Responses to Reviewers

Response to Reviewer 1 Comments

Figure 5: Electrical schematic and final design of the basketball retrieval and return robot.

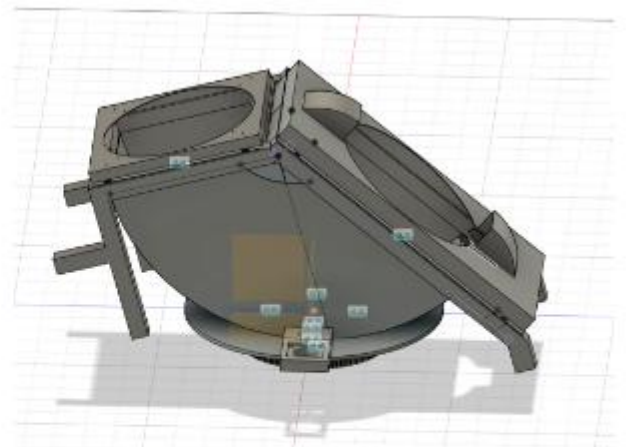
Comments 1: Missing pictures of final design.

Response 1: We thank the reviewer for pointing this out. We agree that the original draft did not provide enough visual evidence of the completed prototype, which made the final mechanical and electrical design less clear to the reader.

In response to this comment, we have added pictures of the final assembled design in the Design section.
